2 & 3 AKENSIDE ROAD NW3 5BS

A geotechnical and structural assessment of basement planning applications 2015/0851/P and 2015/1207/P and their potential impact on 4 Akenside Road NW3 5BS

Report reference G1504-RP-01-E1

Project Ref. G1504	Project Title. 2-3 AKENSIDE ROAD NW3 5BS	Sheet Ref. Figure 3
	UNDRAINED SHEAR STRENGTH vs DEPTH

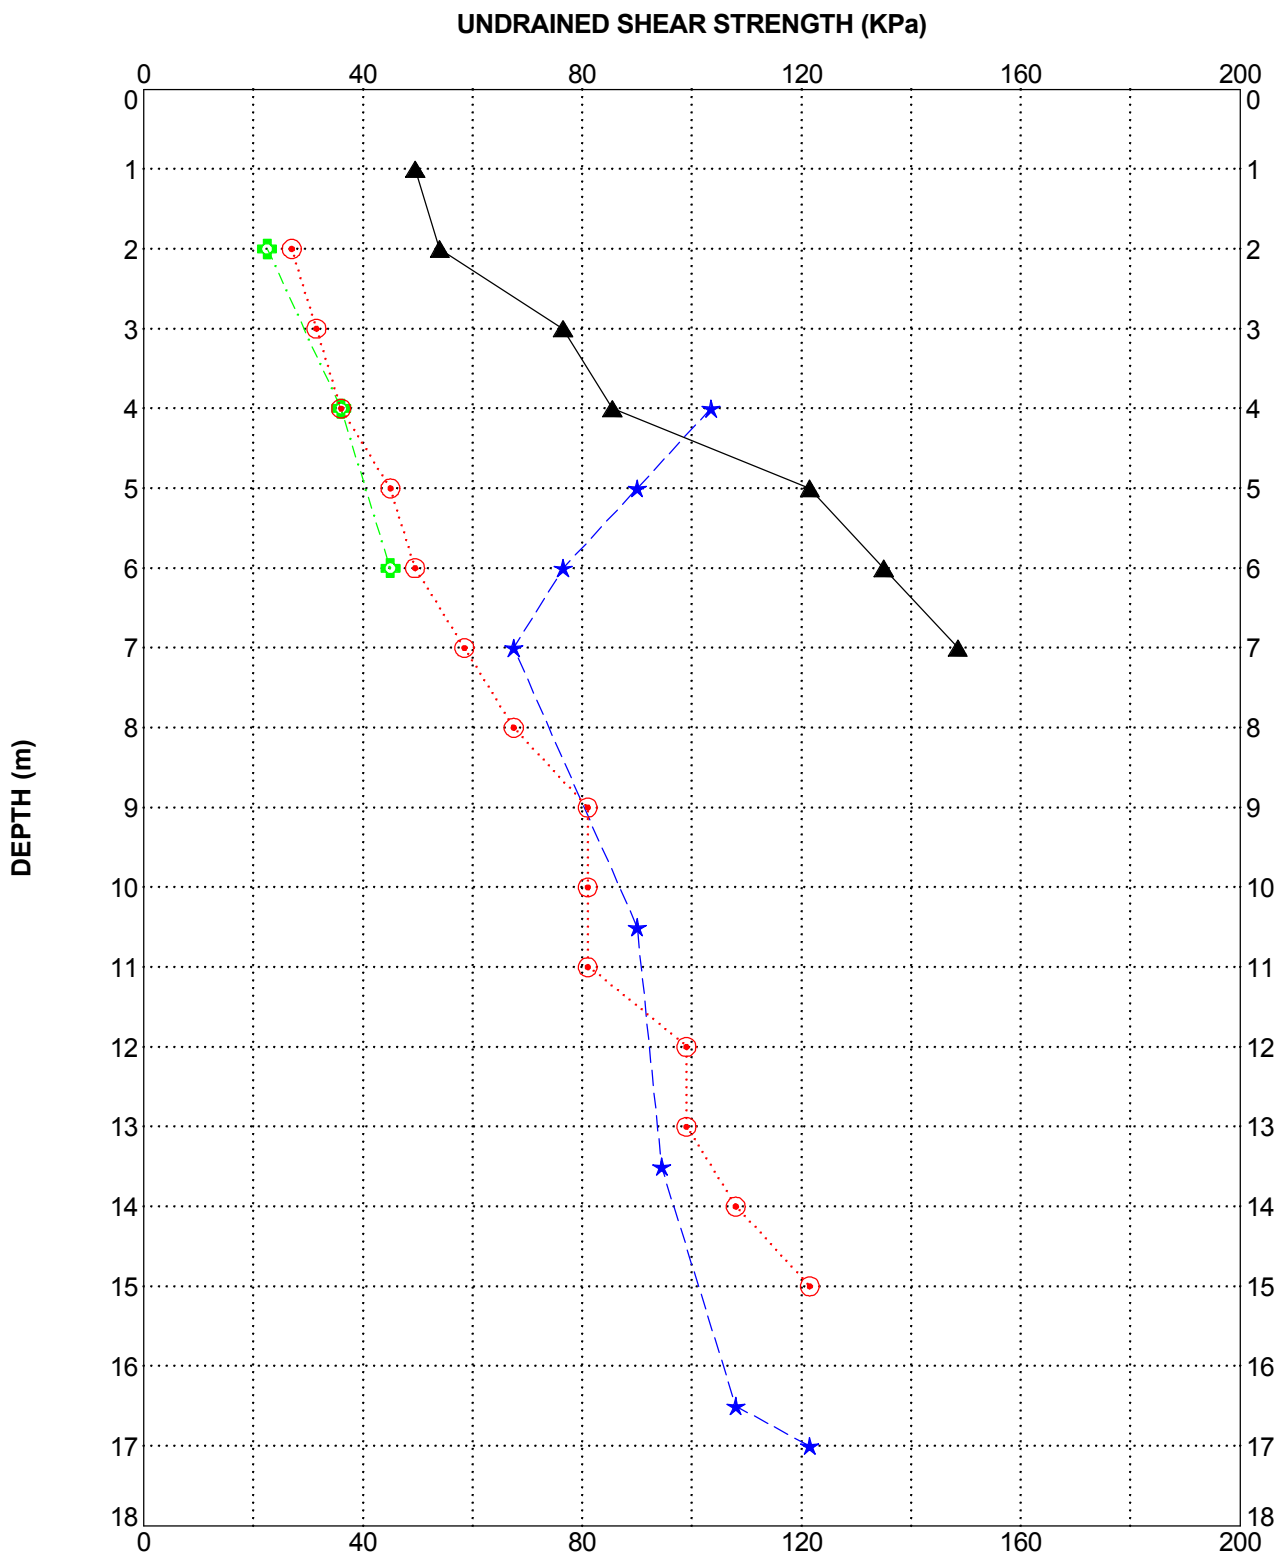
28. Borehole records for 2 and 3 Akenside Road show considerably higher than expected ground strengths and soil descriptions that are at variance with both test results and the written account. To assess their reliability the records were considered in relation to records for some other local sites which exhibit the same mapped geology as Akenside Road, and which are available via the Camden website. Brief details are as follows.

Application documents posted for 6 Wedderburn Road did not include original investigation records; only the BIA account. Ground strength profiles derived from the records for the other four locations have been plotted in Figure 3.

Strengths at Maresfield Gardens and 26 Wedderburn Road fit well with those found by other investigators of the Claygate Member elsewhere in Hampstead but are much lower than those recorded at 2-3 Akenside Road. At the base of the filled ground, the ground strength at Lyndhurst Road was approximately the same as at 2-3 Akenside Road. But strength then decreased quite rapidly with depth, joining the Maresfield Gardens profile at 7m below ground level. No explanation of the upper part of the Lyndhurst Road profile or of a note on the record sheet stating that the borehole was terminated due to groundwater inflows.

The inescapable conclusion is that the results of the ground investigation at 2-3 Akenside Road are unreliable, that the soil descriptions provided are at variance with both test results and the written account and that the information provided is of little or no use for the engineering design of the proposed development or for assessing damage risk for other property.
